65FR#8752
22 Feb 00
(10)

Questions/Comments on the NRC "Draft final technical study of spent fuel accidents risk at decommissioning nuclear power plants", 7590-01-P.

FIGURE 1: Envelope Ground Response Spectra for a (principal) horizontal GM direction, relating to exceedance frequencies 10^{-5} , 10^{-6} and 10^{-7} annual events per site and damping ratios 0.005, 0.02, 0.05, 0.07 and 0.10.

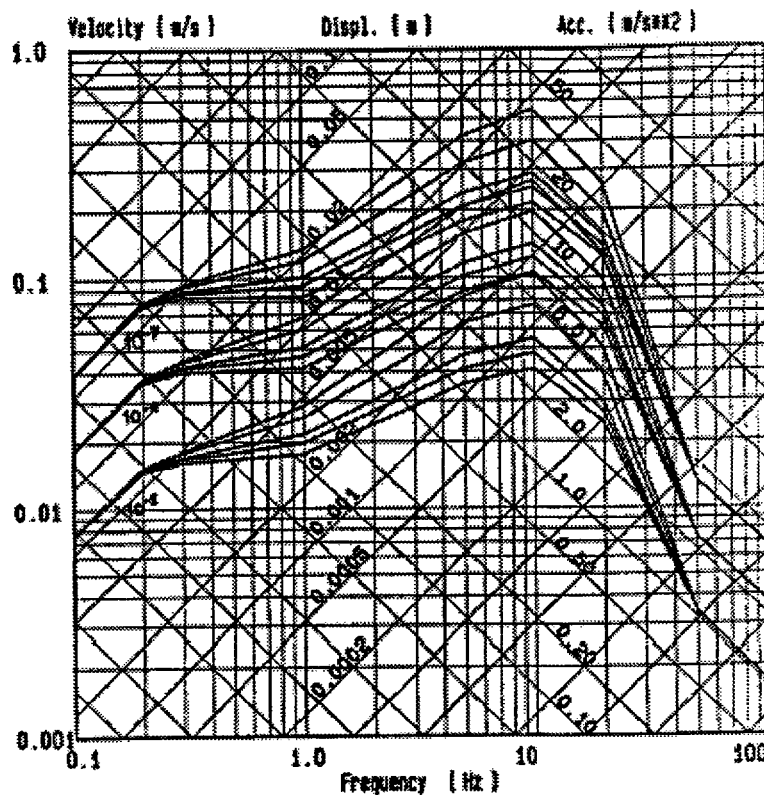
5. An US earthquake response spectra 10^{-5} /year (0.5g) is considered as a 10^{-7} in Sweden. Does this justify exemption from further consideration, due to low yearly frequency for Zr-fire? The SFP at the Swedish plant is calculated with an earthquake 0.1g, see response spectra Figure 1, and found to comply with the Swedish standard design standard (Boverkets Konstruktionsregler 94, BKR94).
